Local Government Official Information and Meetings Act 1987 (LGOIMA) request for information on cycleway safety issues at Wharf Street

DCC: Wharf Street Corridor Improvements

Wharf Street / Birch Street Intersection

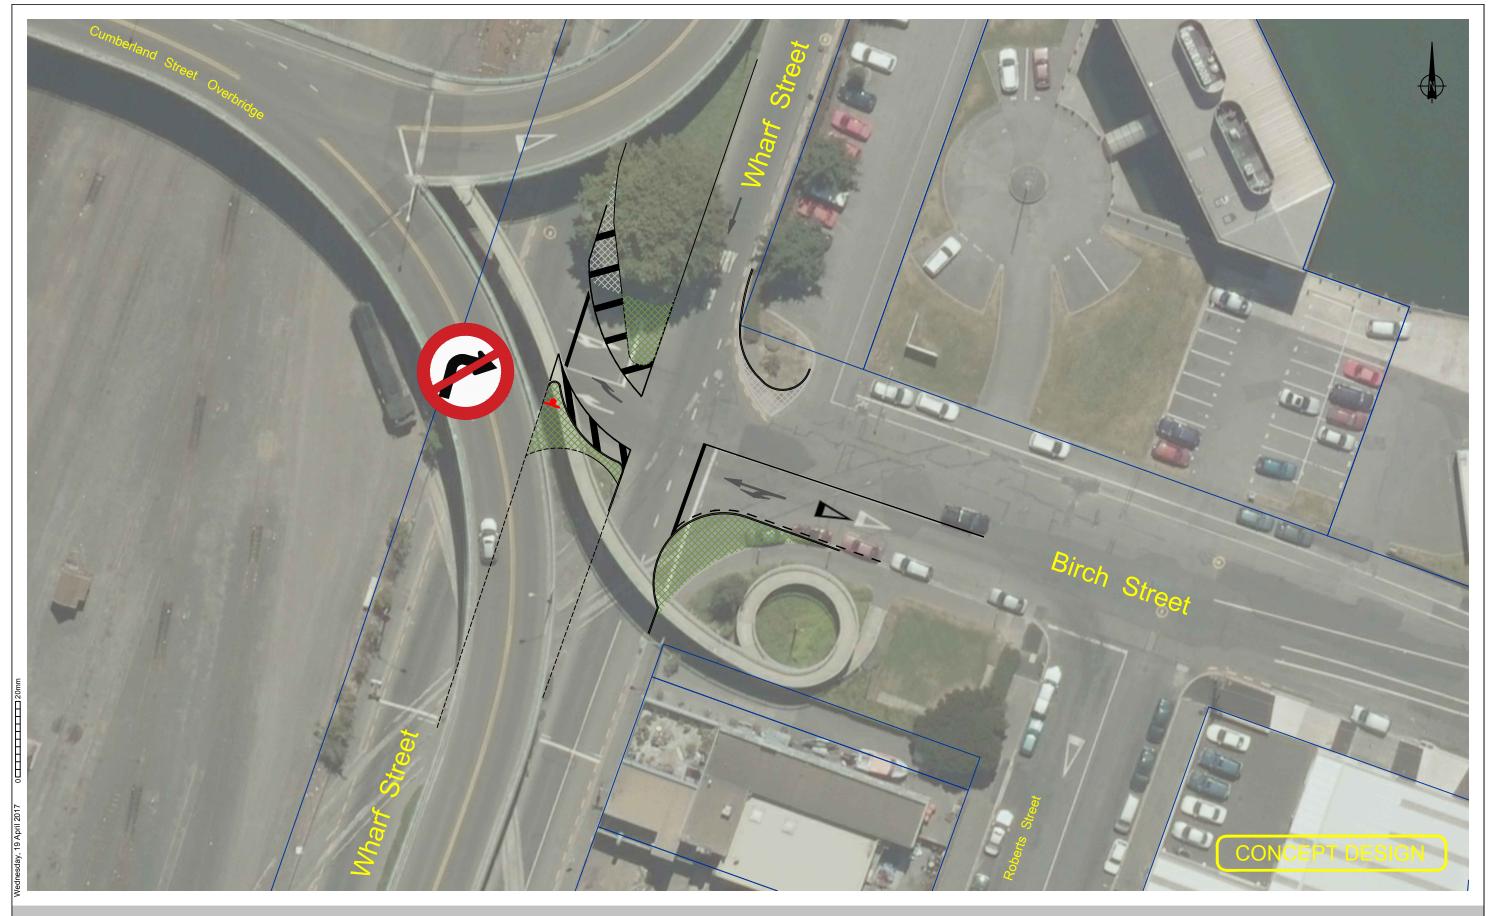
My preference is Option 2, but with a 'pram crossing' drop kerb to be designed in (notes below).

Hjarne - Based on your last Birch Street concept, my idea for cycle movements are -

- exiting Birch Street, in/citybound (red arrow);
- and in or outbound (green arrow), placed after Birch to avoid the Birch St exiting vehicles (and hopefully close the cycle crossing under the on-ramp).

That will create a bit of circulation conflict amongst cyclists, which can hopefully be managed with wider shared paths on both sides.

Angus, the green arrow approximate location would require a wide pram crossing (smooth ride). A Plato vehicle entrance is there, but I'm not sure if it is in the right place or whether it can be co-used. A wide crossing would also cater for cyclists who have somehow come along Wharf St and want to access the shared path without making a hard right.

The new Birch Street concept also comes with a new kerb alignment on the Birch/Wharf St corner, for tying it all in.
